The comments in green were made by Kendra Hanagami, and can be contacted at khanagam@auroragov.org

FOUNDRY COMMUNITY CENTER & PARK
SITE PLAN
A PARCEL OF LAND LOCATED IN SECTION 29, TOWNSHIP 4 SOUTH, RANGE 65 WEST OF THE 6TH PRINCIPAL MERIDIAN,
CITY OF AURORA, COUNTY OF ARAPAHOE, STATE OF COLORADO
FOUNDRY SUBDIVISION FILING NO. 1
25950 E. ILLIFF PLACE

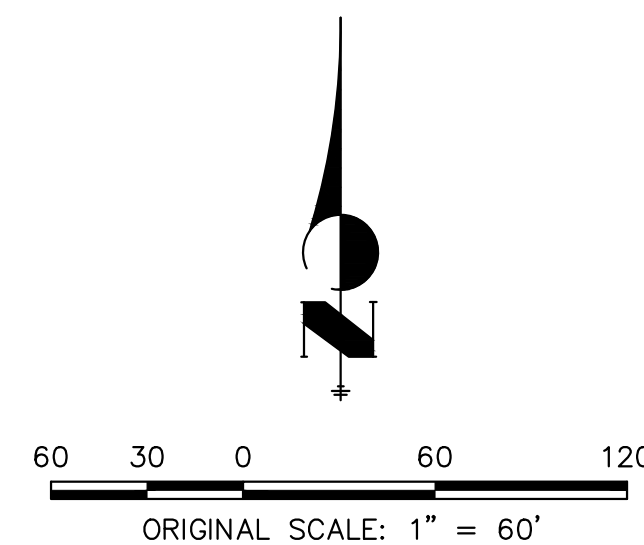
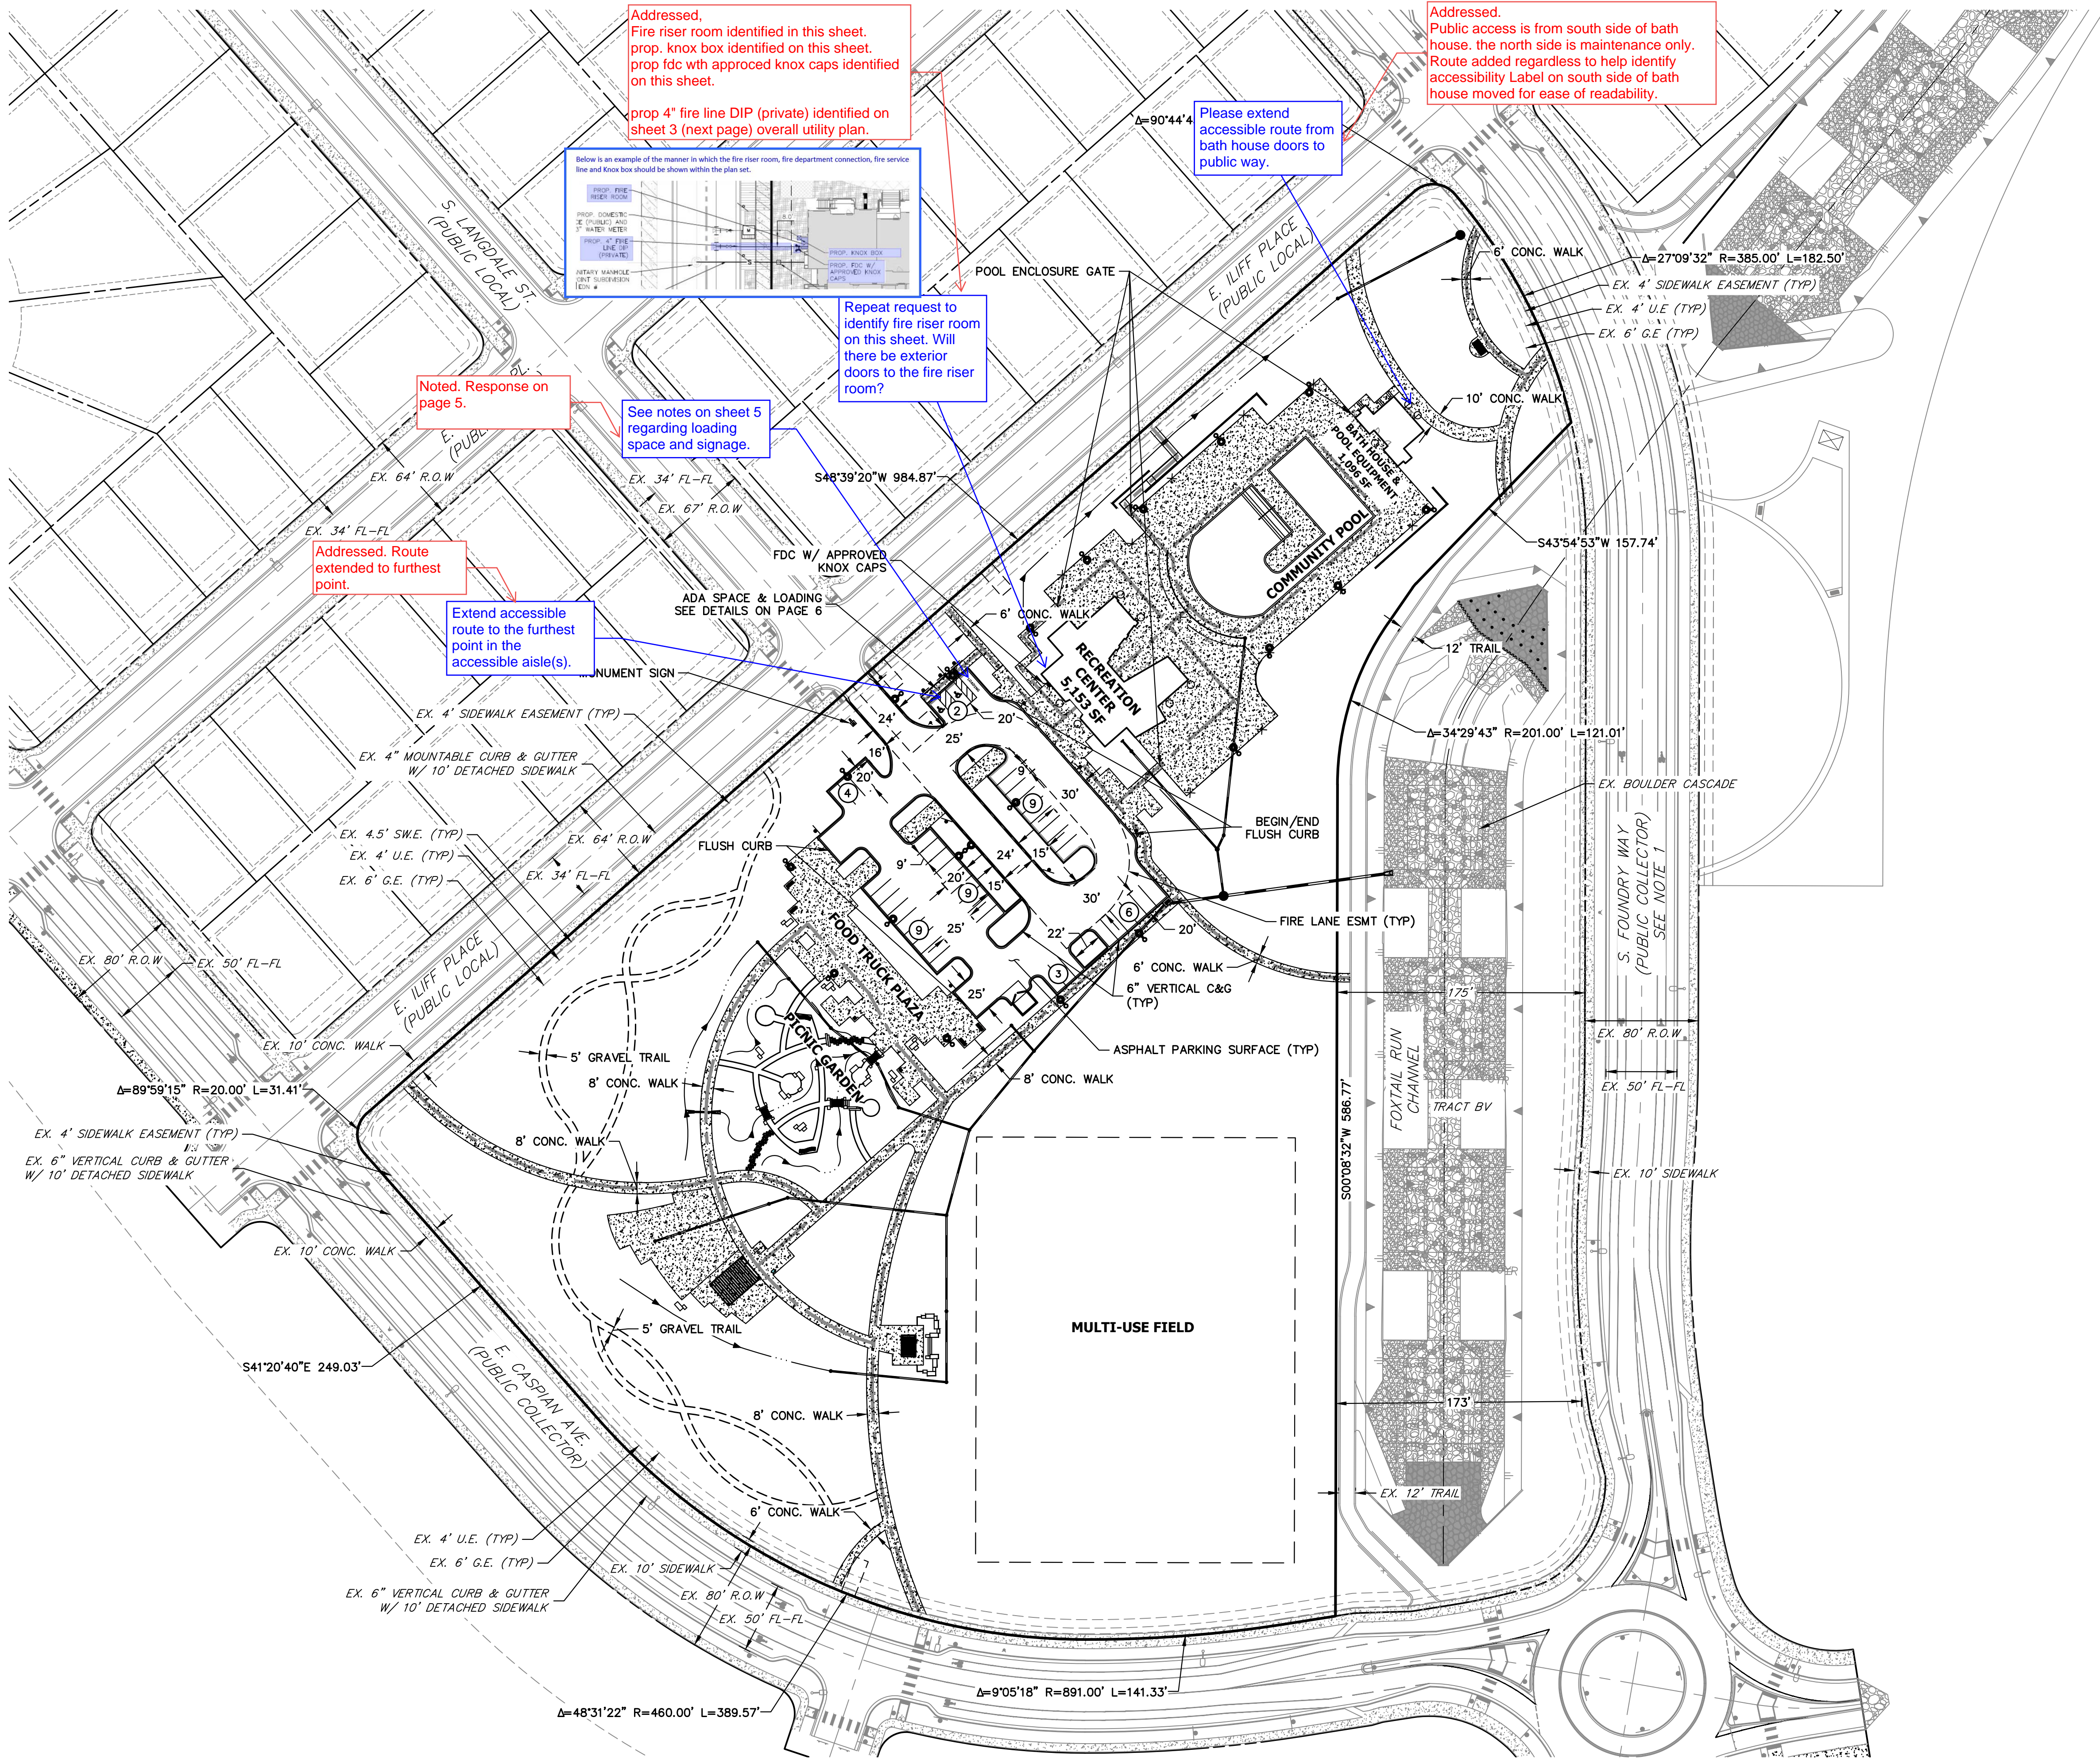
Is the bath house to be sprinklered?

This Site Plan will not be approved until the Preliminary Drainage Report has been approved.

spelling

Addressed,
Sprinklered removed
from bath house.

Noted.

Addressed,
Spelling corrected

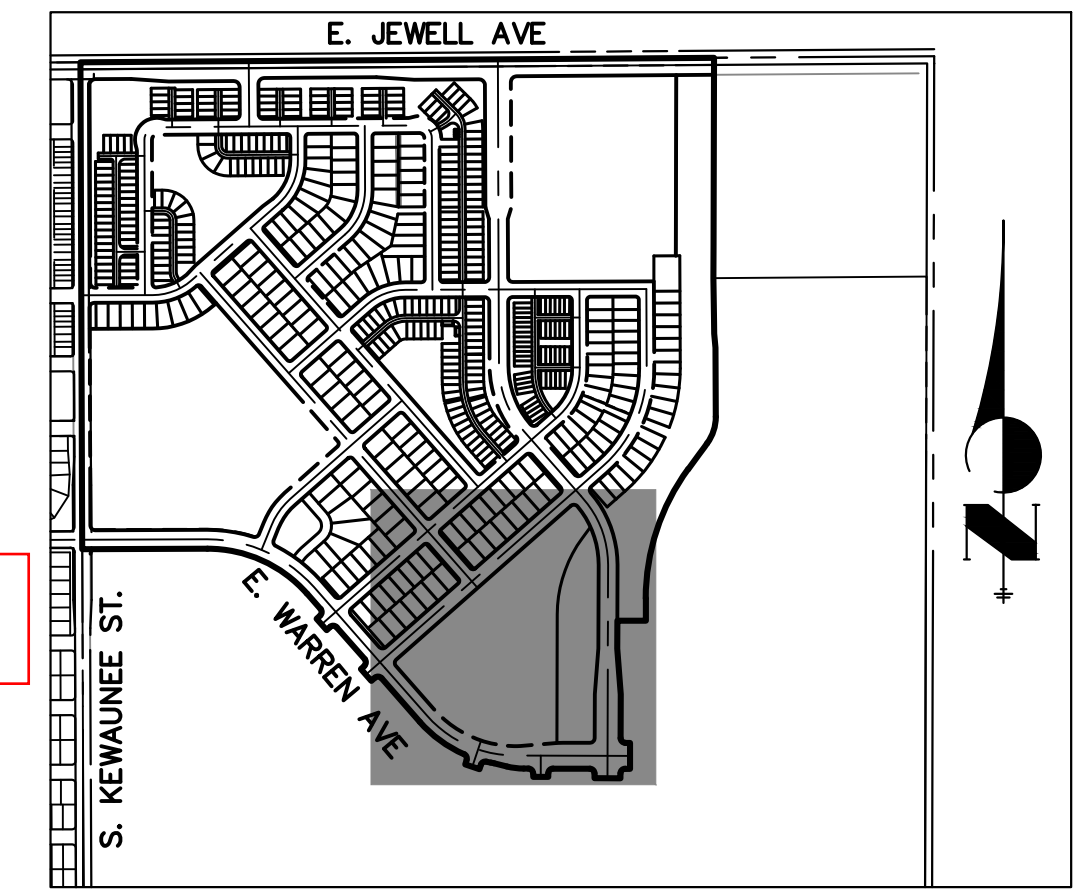
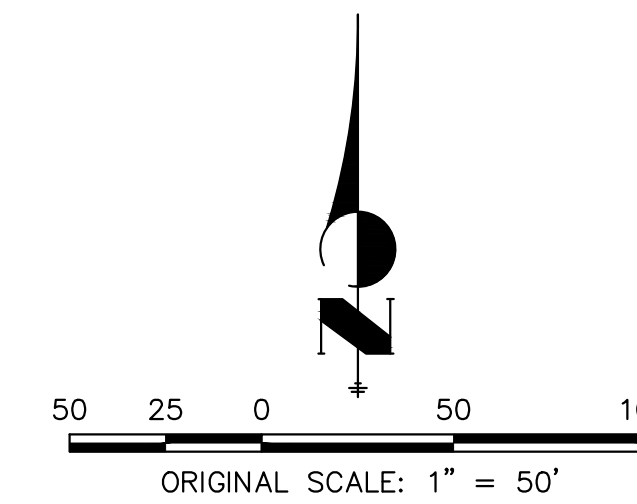
Add the following notes:

All storm infrastructure shall be Private and maintained by the District, unless otherwise noted.

Addressed,
Notes added.

SITE PLAN

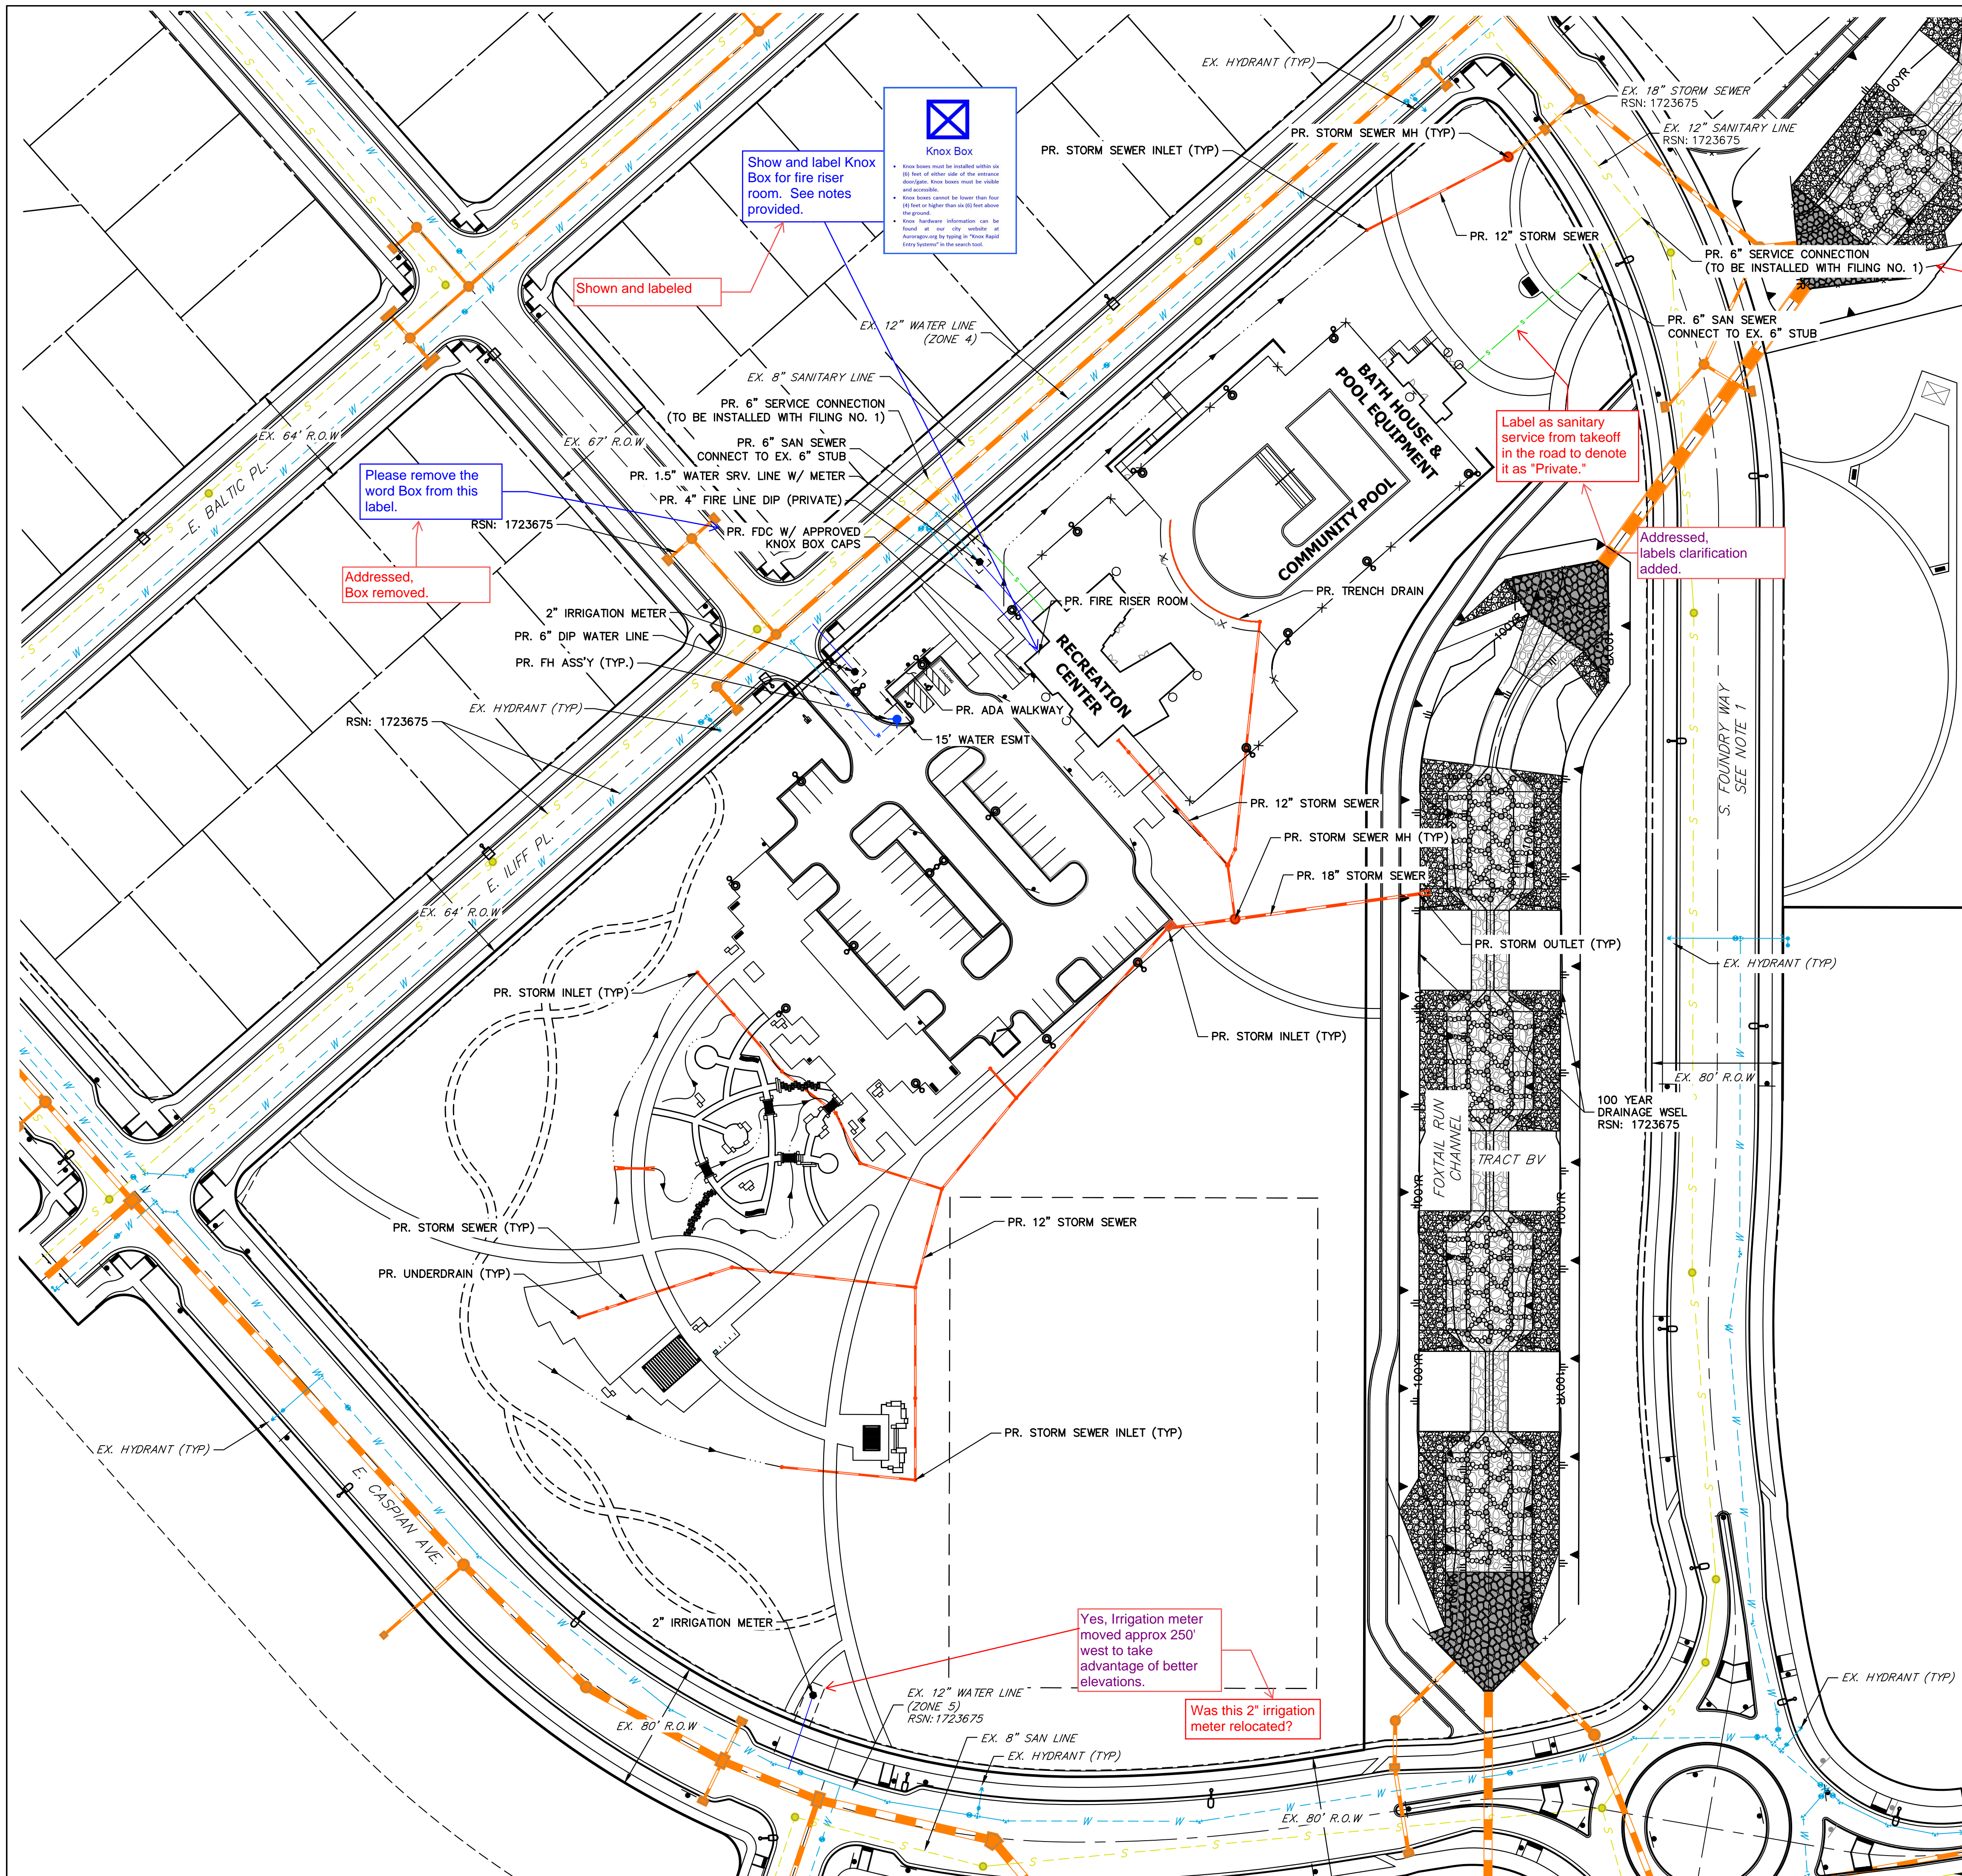
Show and label Knox Box for fire riser room. See notes provided.

Please remove the word Box from this label.

Provide RSN/EDN number if received before signature set.

Addressed, labels clarification added.

Addressed, RSN/EDN number added
